ADDENDUM NO. 2

PROPOSED STORM DRAINAGE CDBG PROJECT CITY OF BAINBRIDGE

PROJECT # 2022-06 April 18, 2025

PROPOSED PUMP STATION SECTIONAL ELEVATION

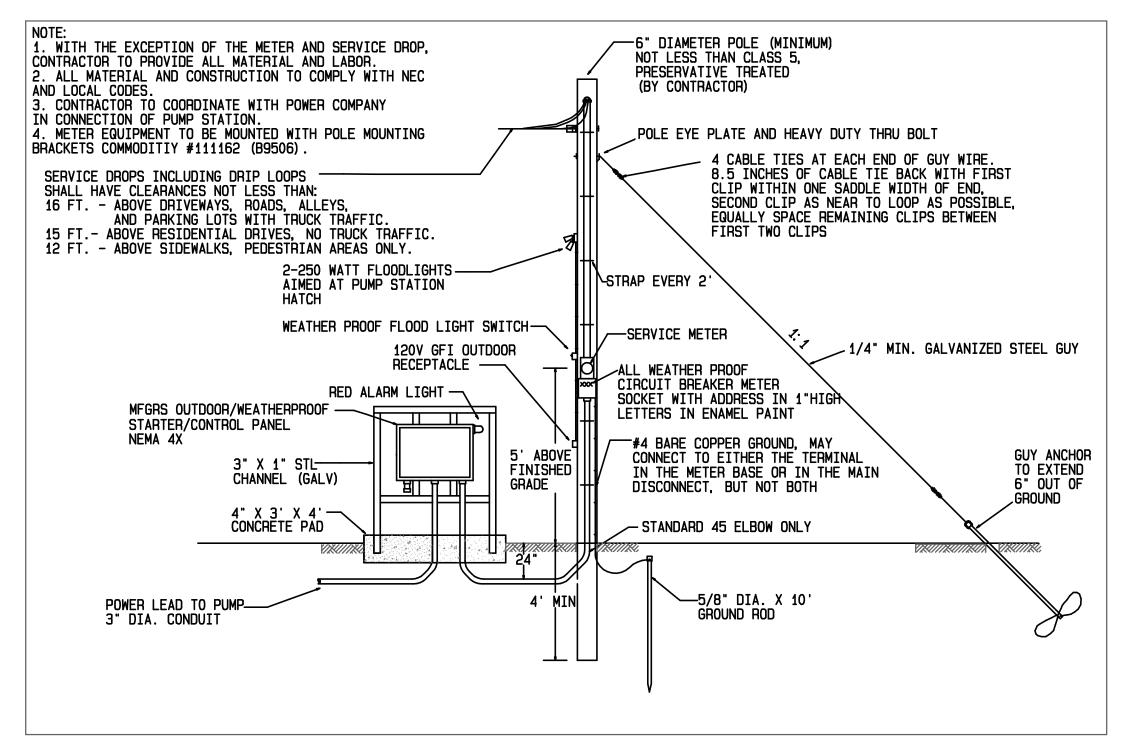
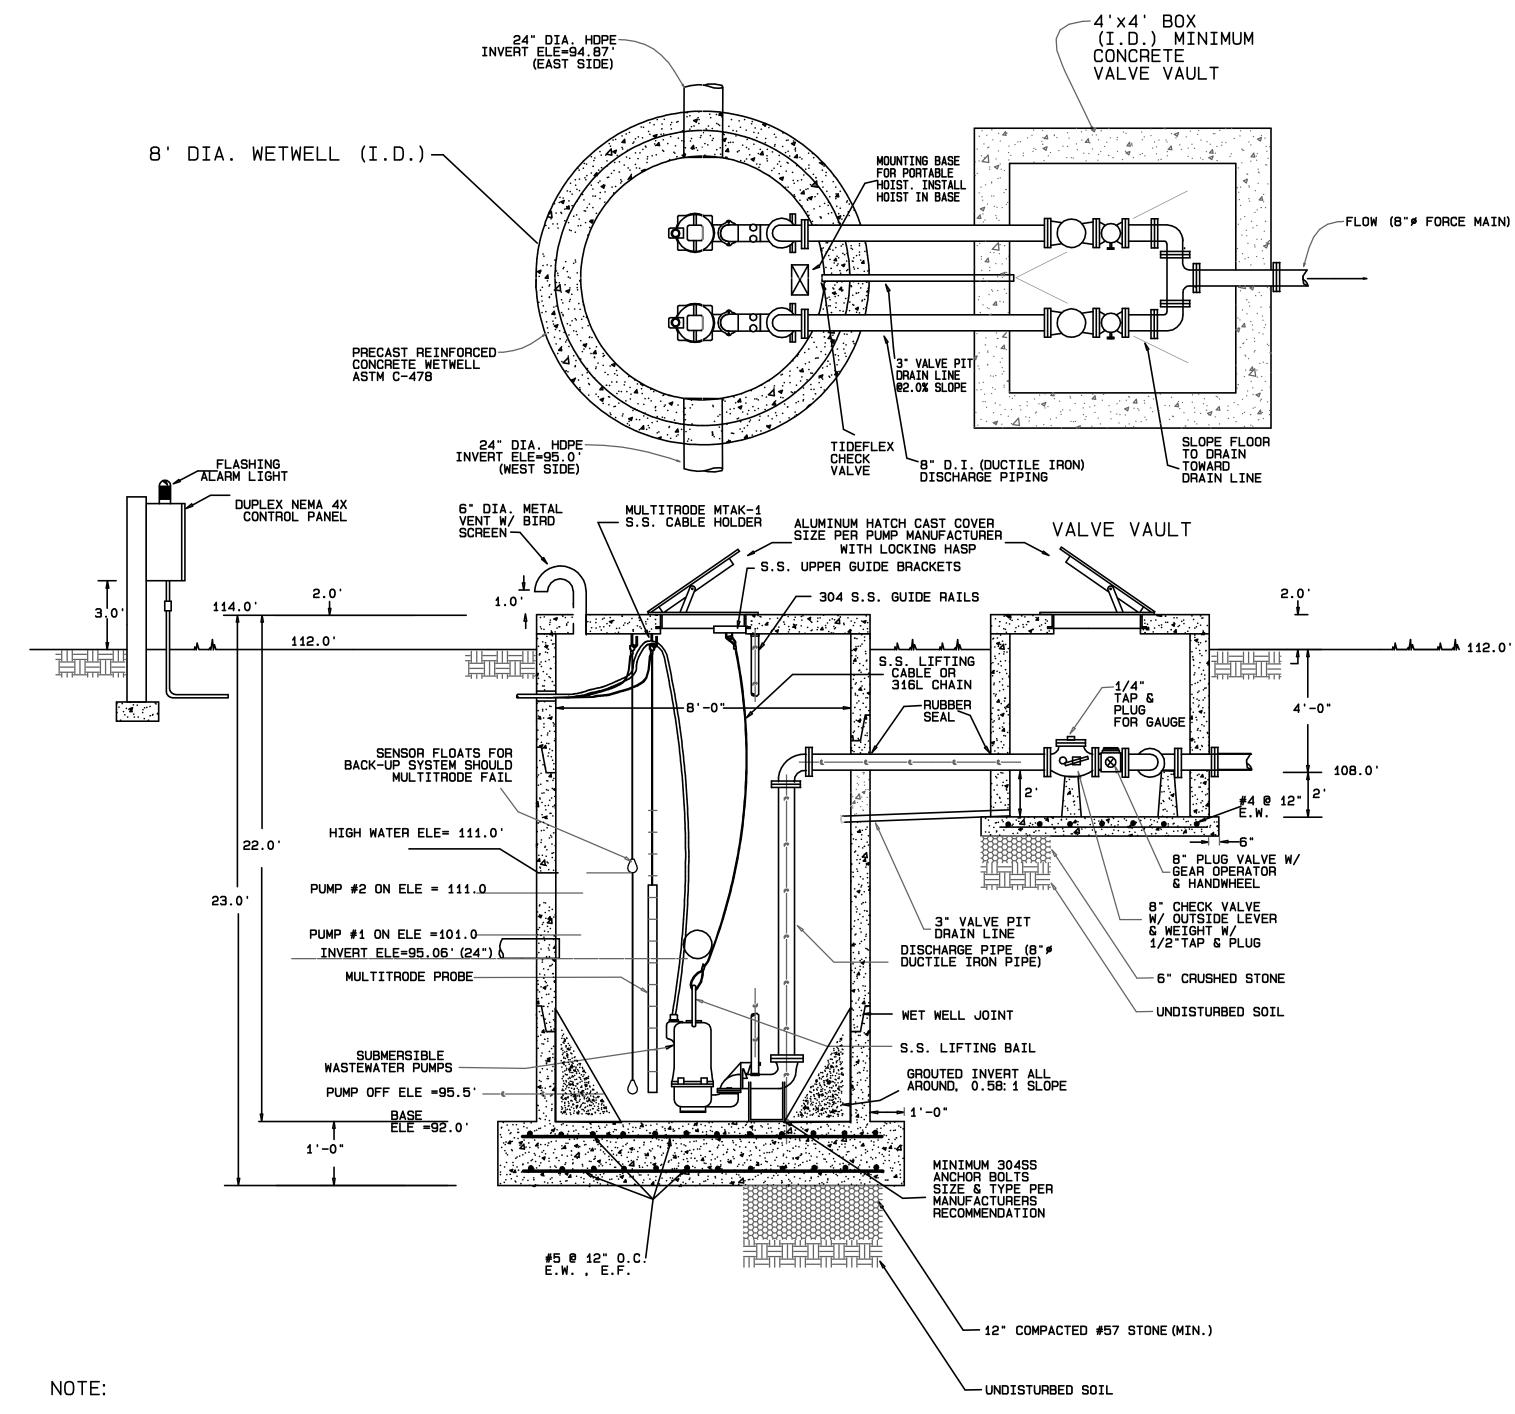
A. Sheet 6 of 17 of the Construction Plan, to be replaced with the attached revised Sheet, revising the voltage from 230V to 460V.

1 REVISED VOLTAGE TO 460V 04/18/25

PROPOSED PUMPS AND PANEL CONTROL PUMP STATION WILL BE: CAPABLE OF PASSING A 3" SOLID, 3 PHASE, 460V, 60HZ, 30.0 HP, 1000 GPM, 64' TDH, 1740 RPM
